Re: Comments on Wind Microclimate Issues – Twickenham Station
RWDI Reference Number: 1010935-PLW(A)

As requested, RWDI has extended the coverage of the study area around the Twickenham Station development to include an assessment of the wind microclimate along Mary's Terrace and in the vicinity of the River Crane, the details of which are provided below. In addition, a clarification of the wind conditions at balconies during the winter months is also provided.

Figure 3 - Balconies

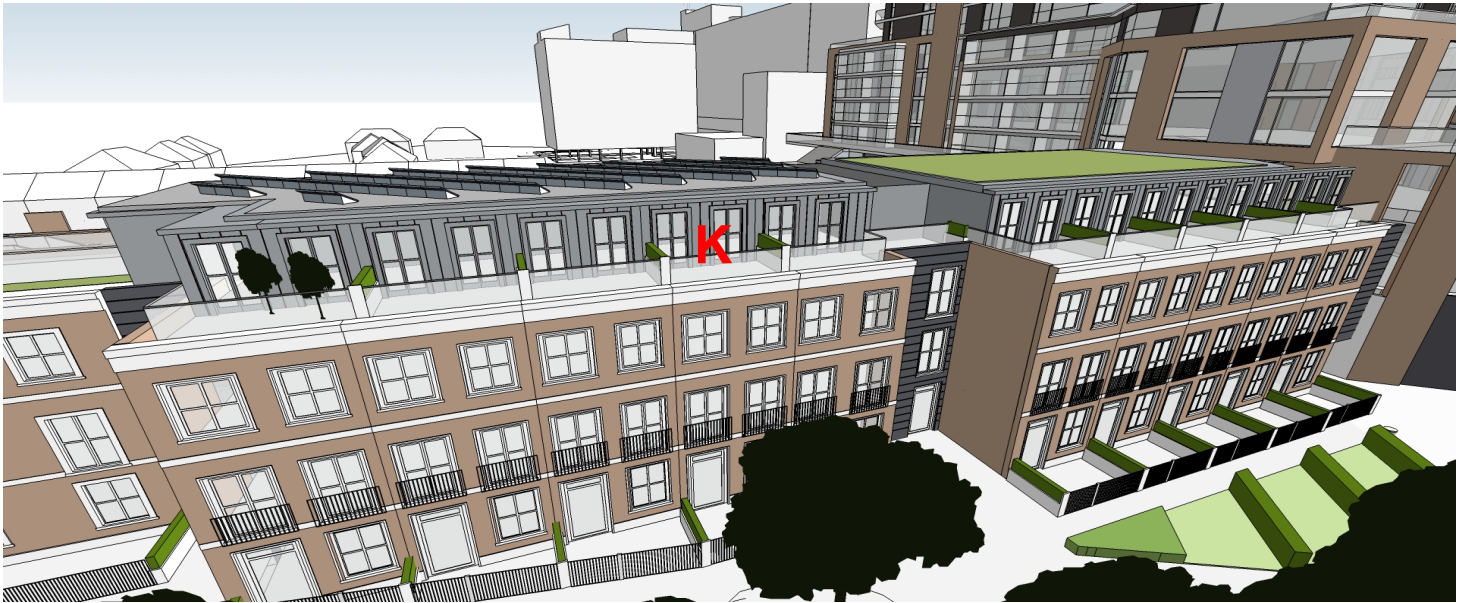
In this assessment the balconies are grouped and labeled for ease of reference and Figures 1, 2 and 3, provided at the end of this document, show those balcony groups.

The group B balconies are recessed and therefore sheltered from the wind, which leads to relatively calm conditions on the balconies. Corner balconies, such as those at locations D and H would usually be relatively windy due to the acceleration of wind around the building corners. However for the Proposed Development, one side of these balconies is fully screened, which prevents cross-flow and creates a calm zone on the balconies. Therefore, the conditions at balconies B, D and H are expected to be suitable for sitting during the summer.

Balcony groups A, C, G and J all protrude from the building façade, which exposes them to cross flows. In previous iterations of the development, full height partition/privacy screens and end screens were included in the 3D model. With such screens in place, the wind would be directed away from the occupied space thereby creating a sheltered zone on the balconies, where sitting conditions would be expected during the summer.

The terraces at location K are expected to be suitable for sitting throughout the summer.

Due to the size, height and building geometry, the remaining balconies are expected to be suitable for a mixture of sitting and standing conditions during the summer i.e. each individual balcony would have areas for sitting and standing. This mixed microclimate is considered acceptable, because it provides residents with useful amenity space that would be suitable for sitting. It should be noted that a standing/entrance assessment does not mean that the area would never be suitable for sitting; it would simply be suitable for sitting less often than a zone classified as suitable for sitting, and perhaps limited to days when winds are generally light or the balcony is located on the downwind side of the building.
